V2500-A1/A5/D5 SERIES PROPULSION SYSTEMS SERVICE BULLETIN

This document transmits Revision 1 to Service Bulletin EV2500-72-0497 and Revision 1 to the Supplement

V2500-ENG-72-0497

ENGINE – REDESIGNED NUMBER 4 BEARING COMPARTMENT OIL NOZZLE BOLT RETENTION

NUMBER 4 BEARING NOZZLE ASSEMBLY
Figure 1

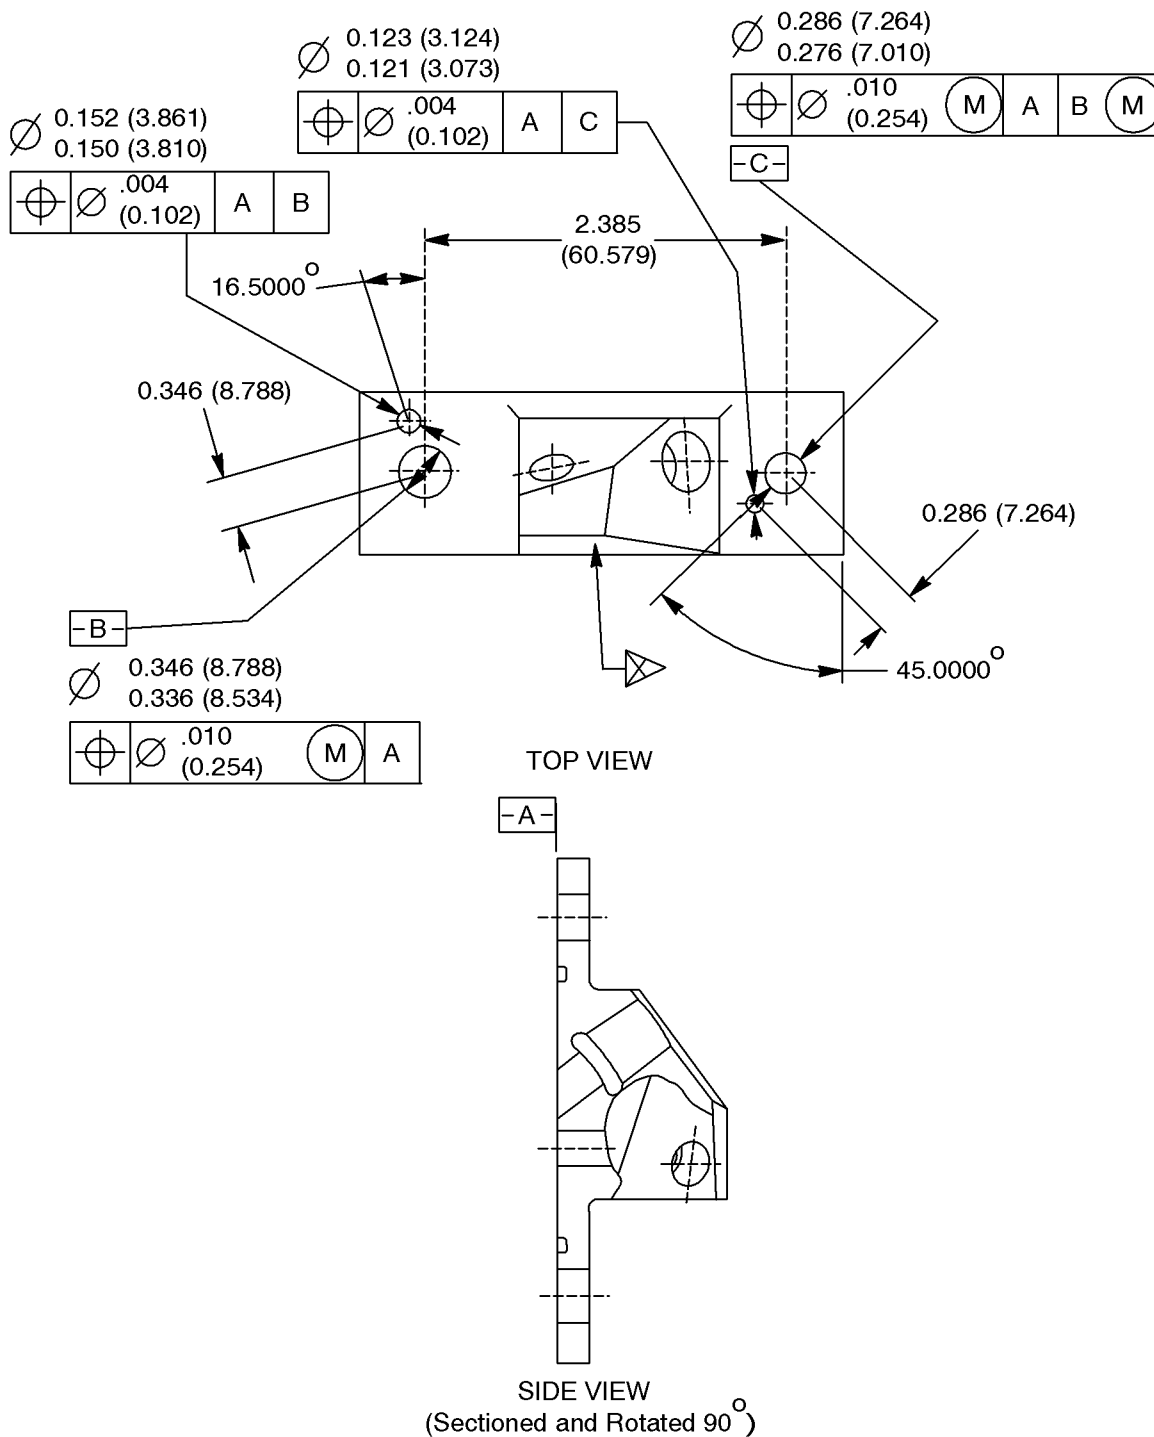
- (c) Cover oil inlet hole to prevent chips from entering the orifices and drill locking tab locating holes thru as specified in Figure 1.
 - (d) Break edges .003 - 0.015 (0.08 - 0.38 mm) .

MARK IDENT PER V2500 SPPM TASK 70-09-00-400-501, SUBTASK 70-09-00-400-001 IN AREA ADJACENT TO EXISTING MARKING

NOTE: The pre-bent tabs on the tab washers must be placed in the locating holes in the Nozzle Assembly before the bolts are torqued. After torquing, the locking tabs must be bent tight against the bolt heads, with no gap between the tab and the bolt head.

FAMILY TREE - HOUSING, NO.4 BRG NOZZLE, ASSY CATALOG SEQUENCE 72-42-34 FIGURE 01
ITEM 010
Chart A

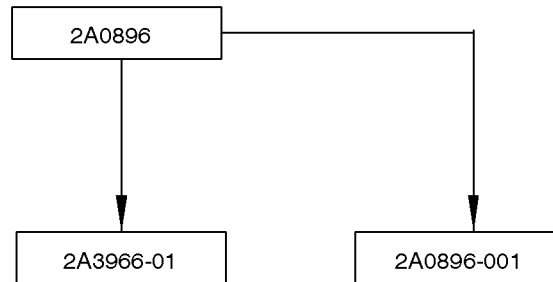
PART NUMBER CHANGE
